ADDENDUM NO. 1

May 26th, 2023

Carmel High School Stadium South Support Building

ADDENDUM NO. 1

G1.6

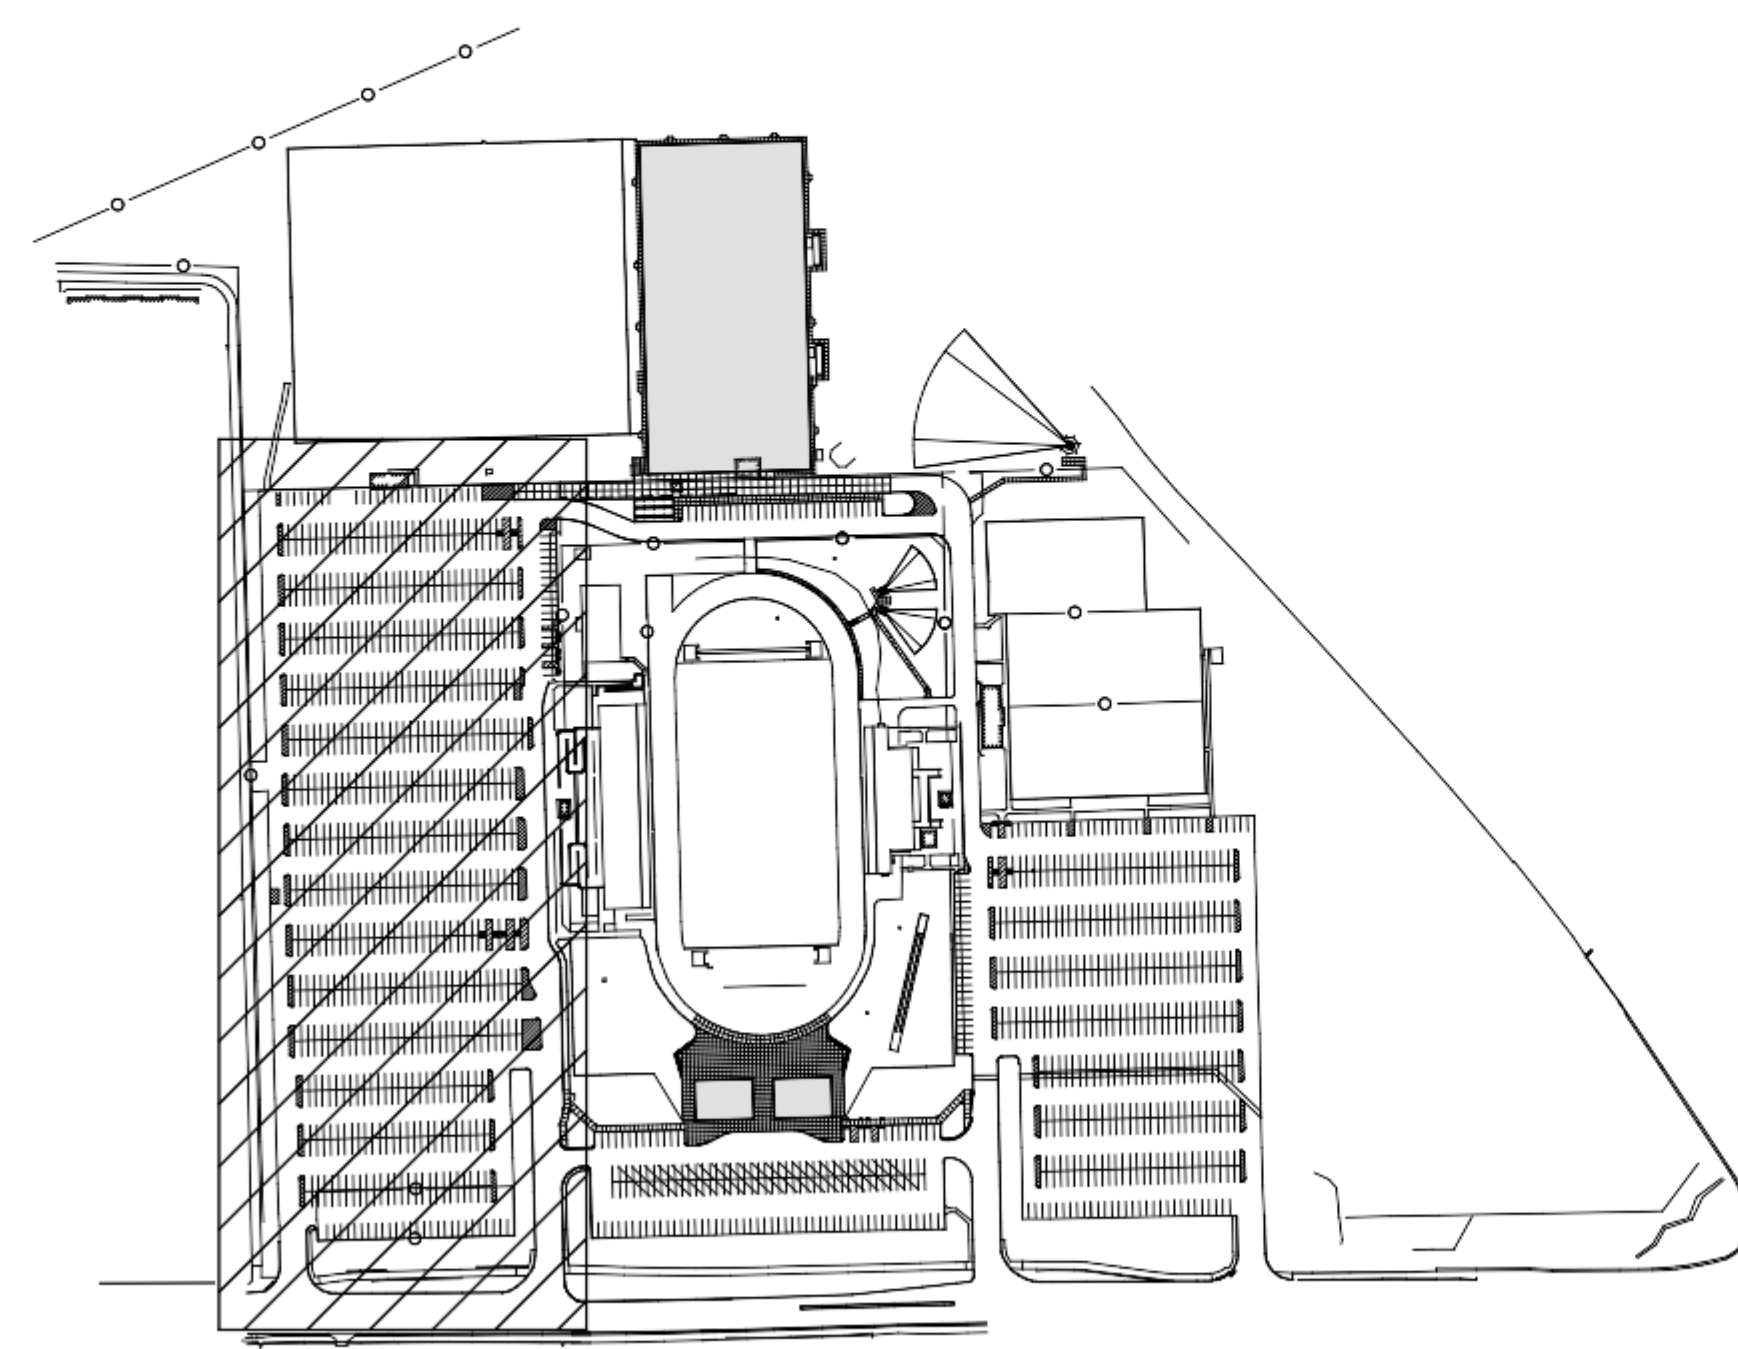
21. All top of wall mineral insulation around steel joist or beams at masonry walls by the Bid Category No. 1 General Trades contractor
22. All work shown in the west parking lot on sheet GD1.6 and sheet G1.06. Reference the attached sheet.
